In the Matter of
METROPOLITAN EDISON COMPANY
(Three Mile Island Nuclear Station, Unit No. 1)
Docket No. 50-289 (Restart)

1. Letter, R. C. Arnold/GPU Nuclear to William Lowe/Pickard, Lowe & Garrick re "Investigation of Potential Safety Issues - TMI-2," dated March 4, 1983, and Attachment.

The safe use of the polar crane to remove the shield blocks and to lift the reactor vessel head is still under review by the GPUNC safety review process and the NRC. We do not prejudge the outcome. The use of the polar crane can be made safe by subjecting proposed activities to such review provided matters listed in Appendix A hereto are considered.

EQUALIZATION ALONG LONGITUDINAL DIRECTION

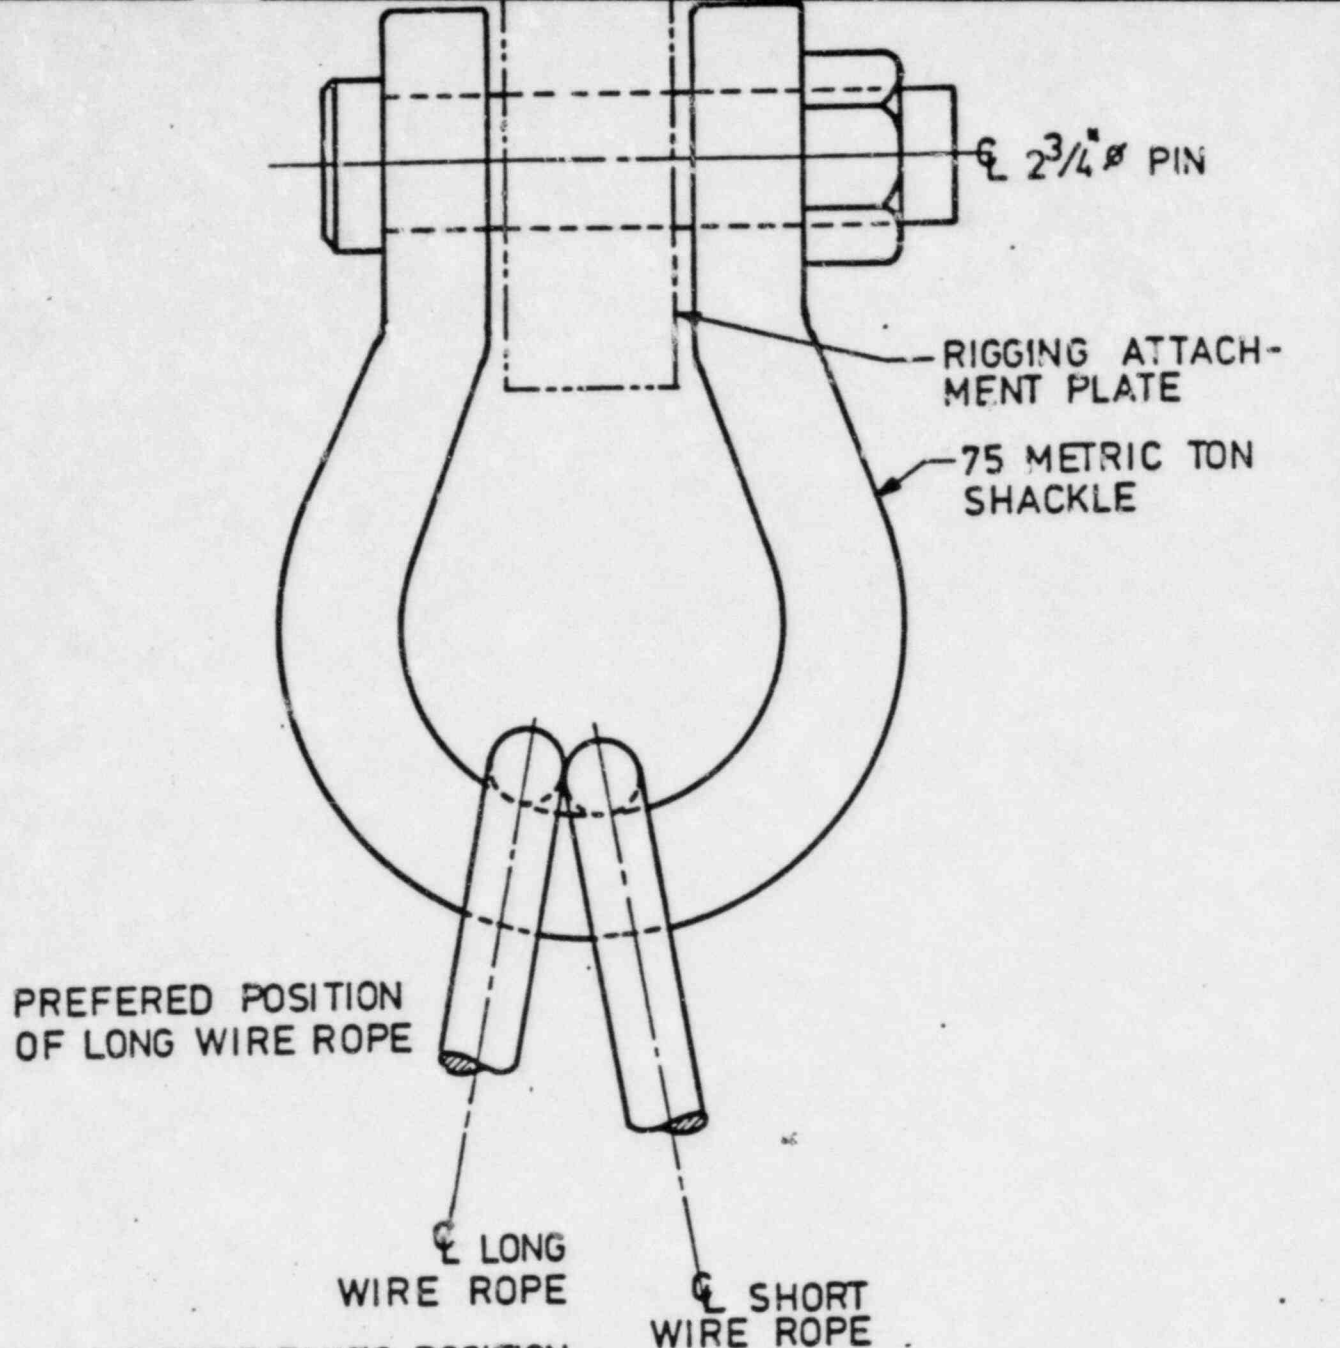
3. The four (4) wire rope slings designed to lift the missile shields were furnished equal length within a tolerance of $\pm 1/8"$ per supplier certification. In addition, the rigging for the missile shields has been designed with load equalizing capabilities built-in. Bechtel Drawing 2-COP-1302, Rev. 2, shows the details of the Missile Shield Rigging Attachment Plate (Detail 5) using a pair of two-leg bridles rather than a single four-leg bridle. Therefore, the rocking action of the attachment plate (see Enclosure 1 attached) about its single pin and the two Crosby shackles, with two sling eyes each in the bail (see Enclosure 2 attached), provide equalizing action to accommodate the tolerance in the sling lengths.

DIFFERENCE BETWEEN SLING LENGTHS GREATLY EXAGGERATED TO SHOW EQUALIZATION EFFECT. ACTUALLY THE DIFFERENCE IN SLING LENGTHS IS LESS THAN 0.123%.
